LaSalle County Station
2601 N. 21st Road
Marseilles, IL 61341-9757
Tel 815-357-6761

LaSalle County Station, Units 1 and 2
Facility Operating License Nos. NPF-11 and NPF-18
NRC Docket Nos. 50-373 and 50-374

Subject: Application for Amendment to Appendix A, Technical
Specifications for the Oscillation Power Range Monitor
Instrumentation

Power/Flow Operating Map for Power Uprate - OPRM Stability Option

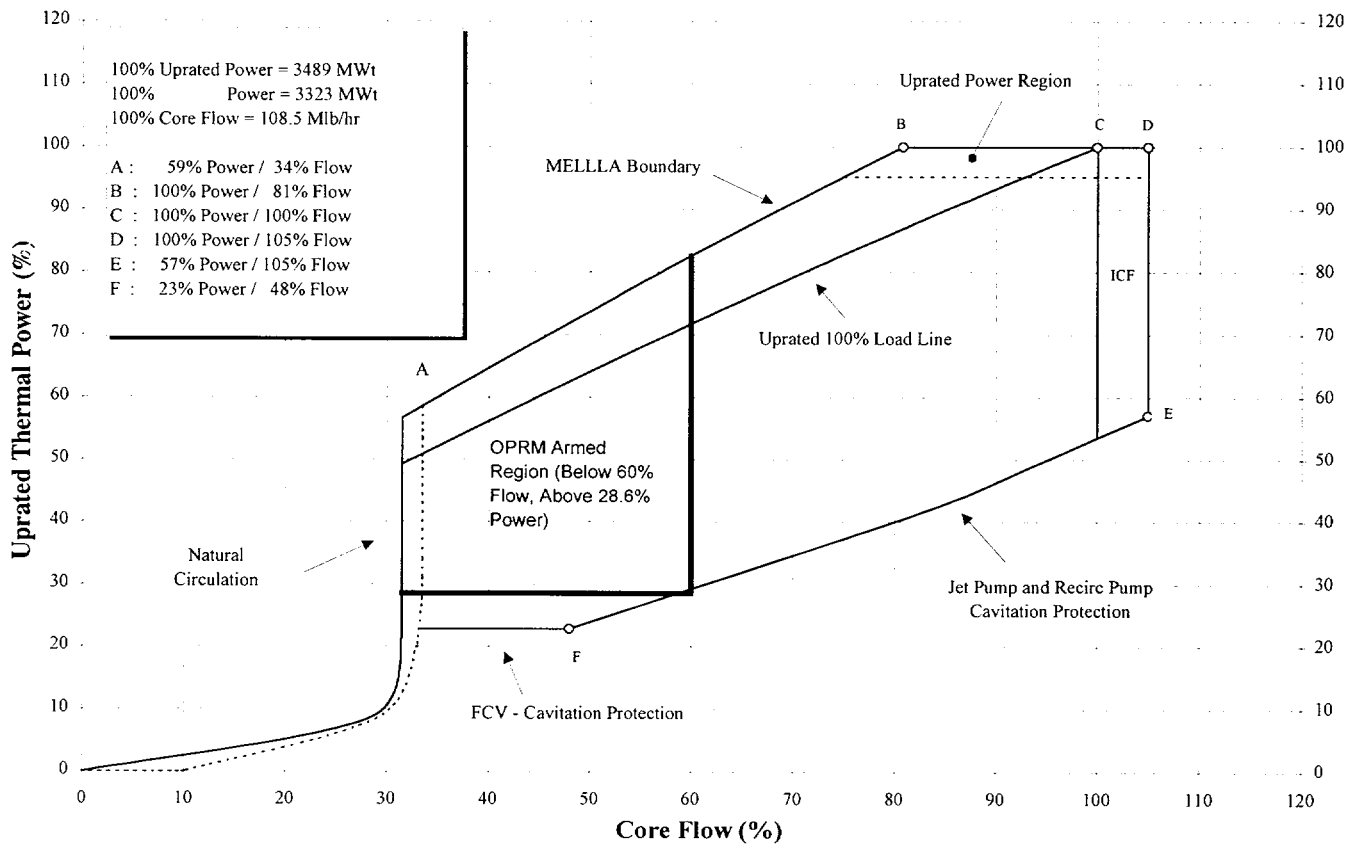
The OPRM Instrumentation trip enabled region of the Power/Flow Operating Map for Power Uprate was submitted by Reference (5) and approved by Reference (6) for LaSalle County Station Units 1 and 2 power uprate.

Figure 3.4.1.5-1

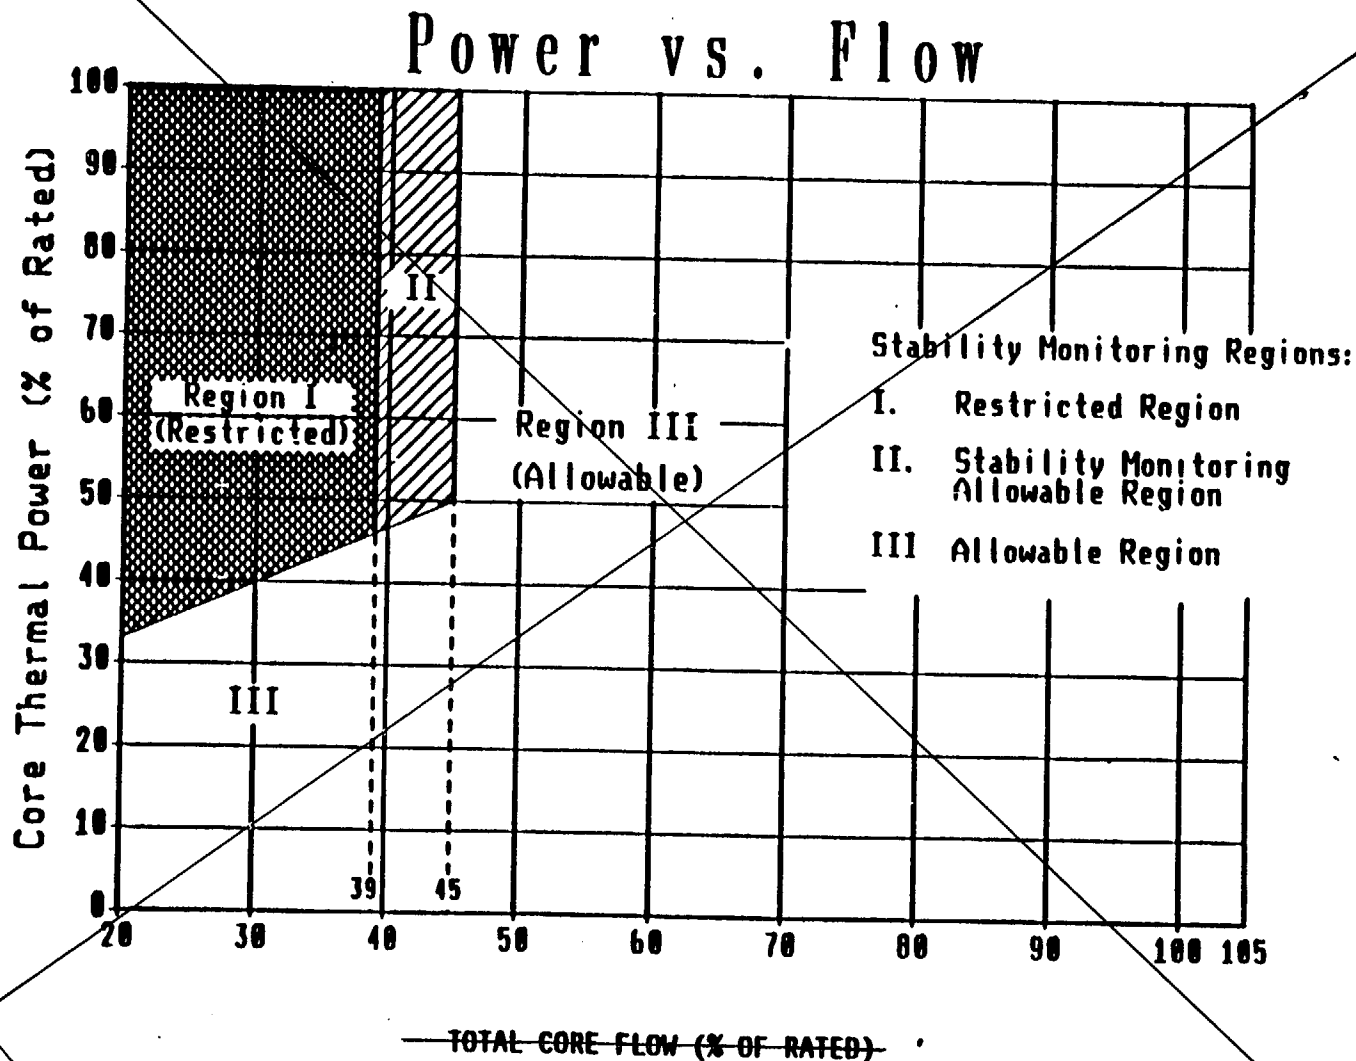
- ~~3.4.1.5 Forced core circulation shall be maintained with:~~
- ~~a. Total core flow greater than or equal to 45% of rated core flow, or~~
- ~~b. THERMAL POWER within Region III of Figure 3.4.1.5-1, or~~
- ~~c. THERMAL POWER within Region II of Figure 3.4.1.5-1 AND APRM and LPRM noise levels not exceeding the larger of: i) Three (3) times the established baseline noise levels or, ii) 10% peak-to-peak indicated noise level.~~

- ~~a. In Region I of Figure 3.4.1.5-1:~~
 - ~~1. With at least 1 reactor coolant recirculation loop in operation immediately initiate action to:~~
 - ~~a) Decrease THERMAL POWER by control rod insertion, completing the power decrease within two (2) hours to exit Region I or,~~
 - ~~b) Increase core flow with the operating Recirculation Loop(s), to exit Region I within two (2) hours.~~
 - ~~2. With no reactor coolant recirculation loops in operation:~~
 - ~~a) Immediately reduce CORE THERMAL POWER by inserting control rods, observing the indicated APRM and LPRM noise levels, and complete power reduction to below 36% of RATED CORE THERMAL POWER within two (2) hours, and~~
 - ~~b) If indicated LPRM or APRM noise levels exceed 10% peak-to-peak, immediately place the reactor mode switch in the SHUTDOWN position.~~
 - ~~c) Comply with Specification 3.4.1.1 ACTION b.2.~~

- ~~b. In Region II of Figure 3.4.1.5-1, with APRM or LPRM neutron flux noise levels exceeding the larger of: i) Three (3) times the established baseline noise levels, or ii) 10% peak-to-peak noise indication.~~
 - ~~1. Immediately initiate corrective action by inserting control rods or increasing core flow to restore the noise levels to within the required limit within 2 hours, otherwise.~~
 - ~~2. Insert control rods to reduce THERMAL POWER and/or increase core flow to enter Region III of Figure 3.4.1.5-1 within the next 2 hours.~~

~~4.4.1.5 When operating within Region II of Figure 3.4.1.5-1, verify:~~

~~Region I of Figure 3.4.1.5-1 represents a region of the power/flow map where instability in neutron flux have been observed. Operation in this region is prohibited to ensure that stable reactor conditions are maintained. Actions to immediately exit Region I are intended to prevent lower priority (i.e., non-emergency) concerns from delaying exit from the region. Observation of neutron flux indications, while not requiring formal surveillance, is needed to avoid reliance on automatic protective systems. A manual reactor scram is required if instabilities are evidenced in Region I with no recirculation pumps operating.~~

~~Operation within a designated surveillance region (Region II of Figure 3.4.1.5-1) requires monitoring of APRM and LPRM noise levels. Observed instabilities require immediate corrective action due to the potential for increasing oscillations.~~

The proposed changes delete CTS Section 3/4.4.1.5 and the associated Power versus Flow Figure 3.4.1.5-1. References to Figure 3.4.1.5-1 are proposed to be deleted from the LaSalle County Station CTS Section 3.4.1.1 and the new OPRM Instrumentation TS are proposed to be incorporated into the CTS as Section 3/4.3.9. Additionally, a reference is added to Section 6.6.A.6, "Core Operating Limits Reports."

Figure 3.4.1.5-1

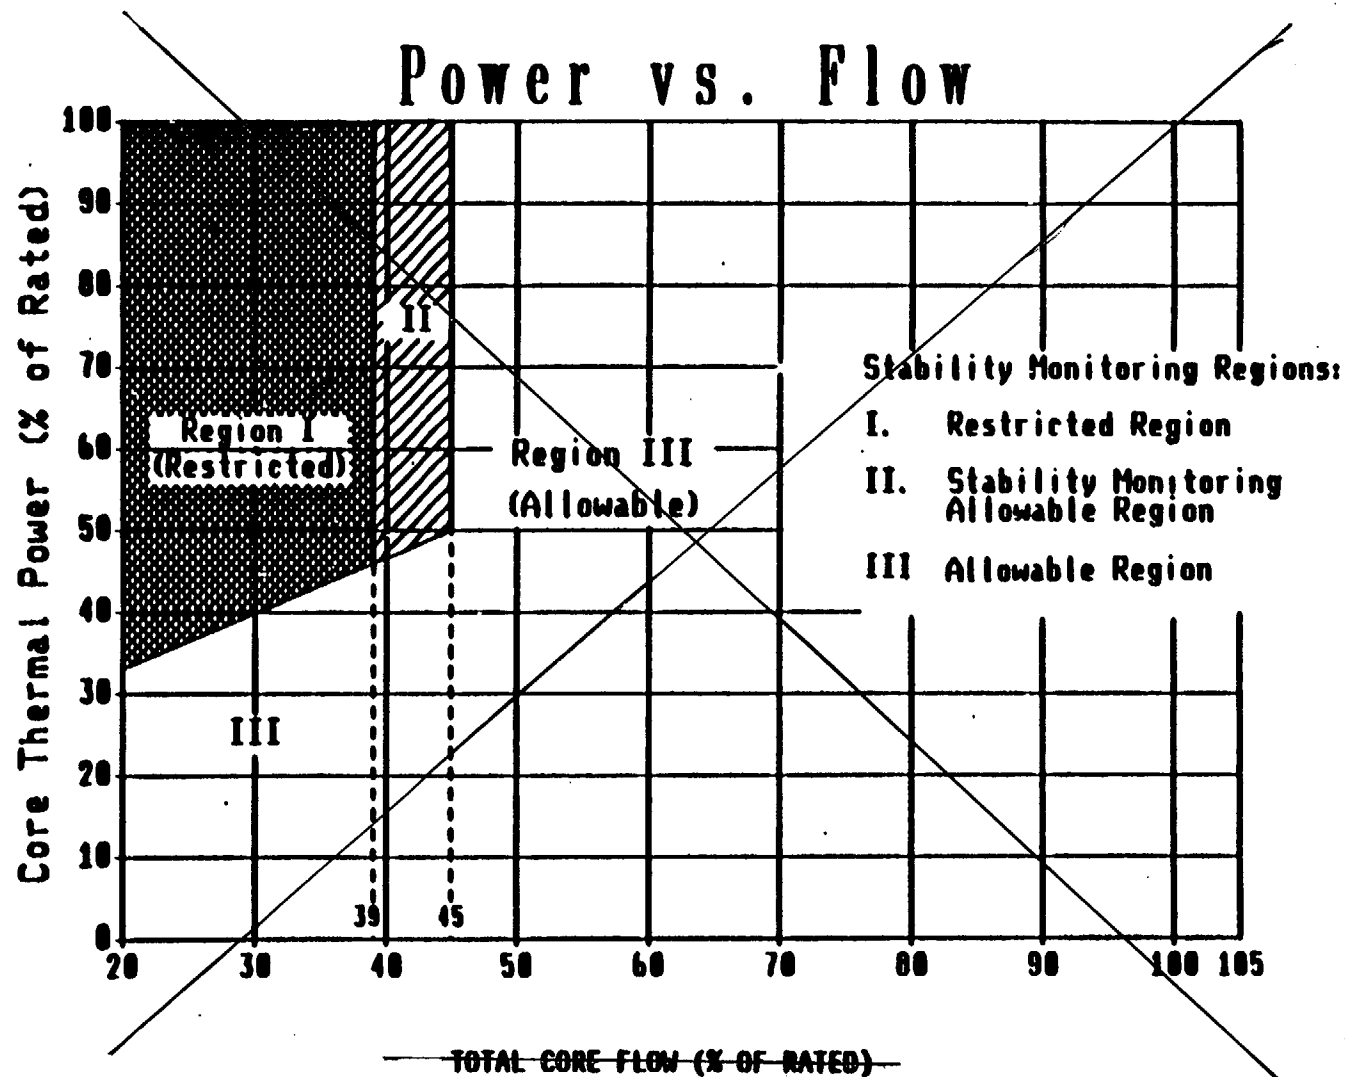
- ~~a. Total core flow greater than or equal to 45% of rated core flow, or~~
- ~~b. THERMAL POWER within Region III of Figure 3.4.1.5-1, or~~
- ~~c. THERMAL POWER within Region II of Figure 3.4.1.5-1 AND APRM and LPRM noise levels not exceeding the larger of: i) Three (3) times the established baseline noise levels or, ii) 10% peak-to-peak indicated noise level.~~

- ~~a. In Region I of Figure 3.4.1.5-1:~~
 - ~~1. With at least 1 reactor coolant recirculation loop in operation immediately initiate action to:~~
 - ~~a) Decrease THERMAL POWER by control rod insertion, completing the power decrease within two (2) hours to exit Region I or,~~
 - ~~b) Increase core flow with the operating Recirculation Loop(s), to exit Region I within two (2) hours.~~
 - ~~2. With no reactor coolant recirculation loops in operation:~~
 - ~~a) Immediately reduce CORE THERMAL POWER by inserting control rods, observing the indicated APRM and LPRM noise levels, and complete power reduction to below 36% of RATED CORE THERMAL POWER within two (2) hours, and~~
 - ~~b) If indicated LPRM or APRM noise levels exceed 10% peak-to-peak, immediately place the reactor mode switch in the SHUTDOWN position.~~
 - ~~c) Comply with Specification 3.4.1.1 ACTION b.2~~

- ~~b. In Region II of Figure 3.4.1.5-1, with APRM or LPRM neutron flux noise levels exceeding the larger of: i) Three (3) times the established baseline noise levels, or ii) 10% peak-to-peak noise indication.~~
 - ~~1. Immediately initiate corrective action by inserting control rods or increasing core flow to restore the noise levels to within the required limit within 2 hours, otherwise.~~
 - ~~2. Insert control rods to reduce THERMAL POWER and/or increase core flow to enter Region III of Figure 3.4.1.5-1 within the next 2 hours.~~

- ~~4.4.1.5 When operating within Region II of Figure 3.4.1.5-1, verify:~~
 - ~~1. That the APRM and LPRM neutron flux noise levels do not exceed the larger of: i) Three (3) times the established baseline levels or, ii) 10% peak-to-peak indicated noise level:~~
 - ~~a. At least once per 12 hours, and~~
 - ~~b. Initiate the surveillance within 15 minutes after entering the region or completing an increase of at least 5% of RATED THERMAL POWER, completing the surveillance within the next 30 minutes.~~
 - ~~2. That core flow is greater than or equal to 39% of rated core flow at least once per 12 hours.~~

~~Region I of Figure 3.4.1.5-1 represents a region of the power/flow map where instability in neutron flux have been observed. Operation in this region is prohibited to ensure that stable reactor conditions are maintained. Actions to immediately exit Region I are intended to prevent lower priority (i.e., non-emergency) concerns from delaying exit from the region. Observation of neutron flux indications, while not requiring formal surveillance, is needed to avoid reliance on automatic protective systems. A manual reactor scram is required if instabilities are evidenced in Region I with no recirculation pumps operating.~~

~~Operation within a designated surveillance region (Region II of Figure 3.4.1.5-1) requires monitoring of APRM and LPRM noise levels. Observed instabilities require immediate corrective action due to the potential for increasing oscillations.~~

Figure 3.4.1-1 (Page 1 of 1)
Power versus Flow

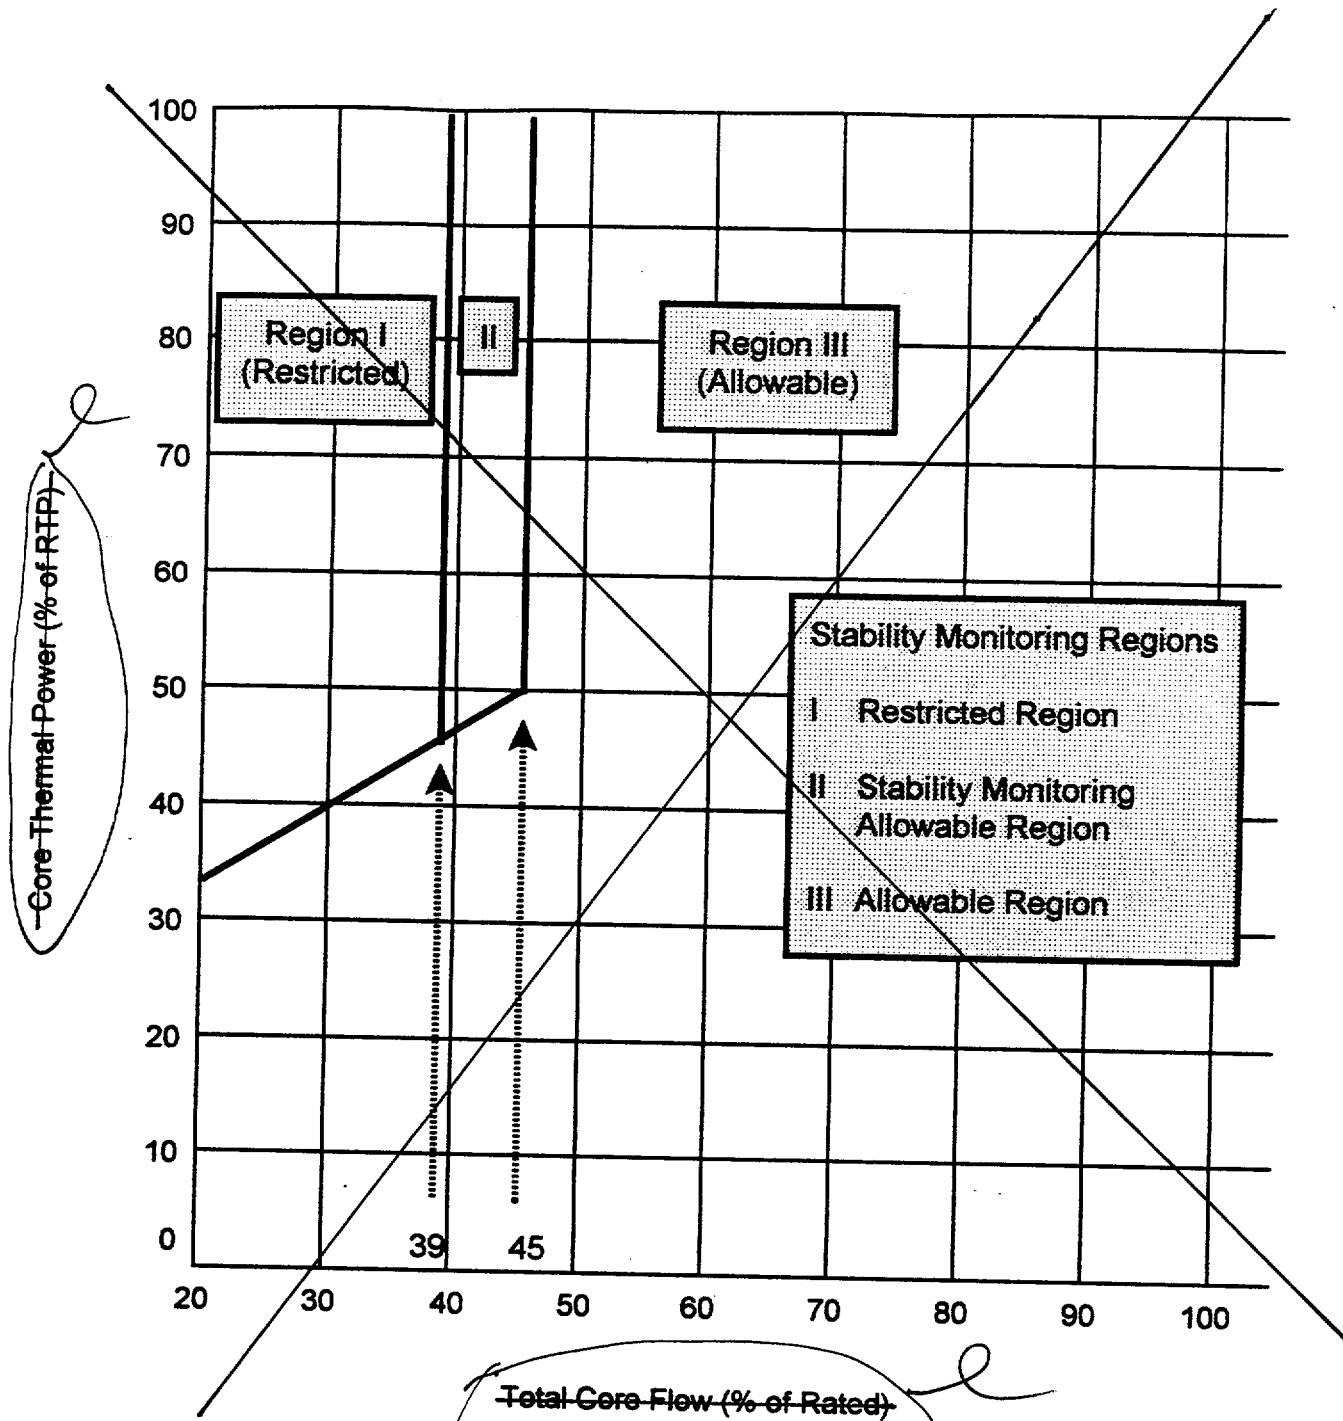
LCO 3.4.1 Two recirculation loops with matched flows shall be in operation ~~within Region III of Figure 3.4.1-1.~~

One recirculation loop shall be in operation ~~within Region III of Figure 3.4.1-1~~ with the following limits applied when the associated LCO is applicable:

CONDITION	REQUIRED ACTION	COMPLETION TIME
A. One or two recirculation loops operating within Region II of Figure 3.4.1 1.	A.1 NOTE Only applicable when 3 times baseline value is > 10% peak-to-peak value ----- Verify APRM and LPRM flux noise levels \leq 3 times baseline.	45 minutes AND Once per 12 hours thereafter AND 45 minutes from discovery of Condition A concurrent with any THERMAL POWER increase of \geq 5% RTP. (continued)

CONDITION	REQUIRED ACTION	COMPLETION TIME
<p>C. One or two recirculation loops operating within Region I of Figure 3.4.1-1.</p> <p>OR</p> <p>Required Action A.3 and associated Completion Time not met.</p>	<p>C.1 Exit Region I of Figure 3.4.1-1.</p>	<p>2 hours</p>
<p>² A. No recirculation loops in operation.</p>	<p>² D.1 Verify APRM and LPRM flux noise levels $\leq 10\%$ peak-to-peak.</p> <p>AND</p> <p>D.2 Reduce THERMAL POWER to $< 36\%$ RTP.</p> <p>AND</p> <p>D.3 Be in MODE 3.</p>	<p>Immediately</p> <p>2 hours</p> <p>12 hours</p>
<p>E. Required Action B.1 or D.1 and associated Completion Time not met.</p>	<p>E.1 Place the mode switch in the shutdown position.</p>	<p>Immediately</p>
<p>^f B. Recirculation loop flow mismatch not within limits.</p>	<p>^B K.1 Declare the recirculation loop with lower flow to be "not in operation."</p>	<p>2 hours</p>

~~operation, the combination of core flow and THERMAL POWER must be in Region III of Figure 3.4.1-1 to ensure core thermal hydraulic oscillations do not occur.~~

~~With one or two recirculation loops in operation in Region II of Figure 3.4.1-1, the plant is operating in a region where the potential for thermal hydraulic oscillations exists. To ensure oscillations are not occurring, APRM and LPRM neutron flux noise levels must be verified to be less than or equal to the larger of either 3 times the baseline noise levels or 10% peak-to-peak (Required Action A.1 and A.2) when Region II is entered. For the LPRM neutron flux noise verification, detector levels A and C of one LPRM string per core octant plus detector levels A and C of one LPRM string in the center region of the core should be monitored. Prompt action to monitor APRM and LPRM neutron flux noise levels should be taken to ensure oscillations are not occurring.~~

1. Delete ITS Power versus Flow Figure 3.4.1-1 and associated references to the figure from ITS Section 3.4.1, "Limiting Condition for Operation (LCO), Actions, and Surveillance Requirements (SRs).
2. Add ITS Section 3.3.1.3, "Oscillation Power Range Monitor (OPRM) Instrumentation" and add a reference to Section 5.6.5, "Core Operating Limits Report (COLR)".
